SERVICE BULLETIN #130

12/12/14

2618 Disc Wheel Drive Hub

Replacement Option

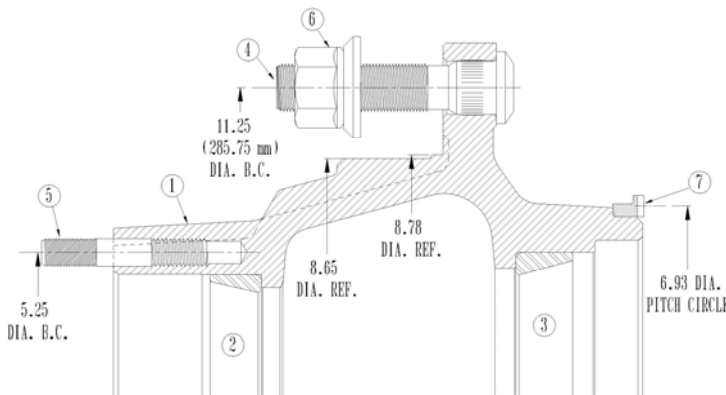
The 2618 series Disc Wheel Drive Hub has been obsoleted. This hub has no direct replacement. We do however recommend an optional replacement: the 10-stud 11.25" B.C. 2614 disc wheel drive hub. This requires changing the hub, changing brake drums, and changing the disc wheels from a 10.827" B.C. to wheels with an 11.250" B.C. If you have any questions, please contact the Webb Engineering department via email to engineering@webbwheel.com or call 256-739-6660.

2614 Bill of Material			
Item	Part No.	Description	Qty
1	2614T	10 Stud 11.25" Outboard Drive Hub	1
2	39520	Outer Bearing Cup	1
3	47620	Inner Bearing Cup	1
4	Varies	M22 Wheel Stud	10
5	152030	5/8-18 Drive Stud	12
6	179935	Flangenut	10
7	51048	ABS Ring	1
